Compilation of comments received on ISO/CD 16110-2

Date:2006-11-08	ISO/TC 197 doc. N 362 Annex 1
	Reference Document: ISO/TC 197 doc. N 351 ISO/CD16110-2 (

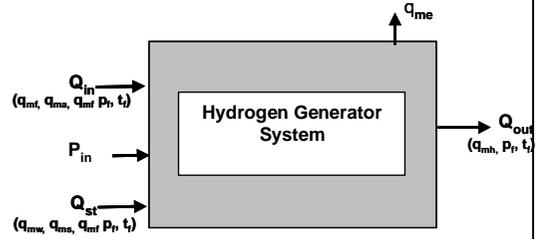
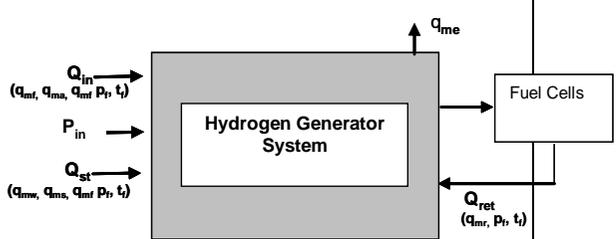
JP	Annex B	Figure B	Te	<p>If some formulas will be defined as calculating fuel efficiency, figure B-Symbol diagram should be revised to appropriate one.</p> <p>In the comment No.10 regarding to the Hydrogen product efficiency, two types of formula are defined. If agreed, appropriate ones should be made.</p>	<p>If no formula, delete the diagram indicated in the CD.</p> <p>FigureB-1 and FigureB-2 shown below will be proposed corresponded to the formula (1) and (2) shown the comment No.10.</p>  <p>Figure B-1 – Symbol diagram(General Application)</p>  <p>Figure B-2 – Symbol diagram(Fuel Application)</p>	
----	---------	----------	----	---	---	--
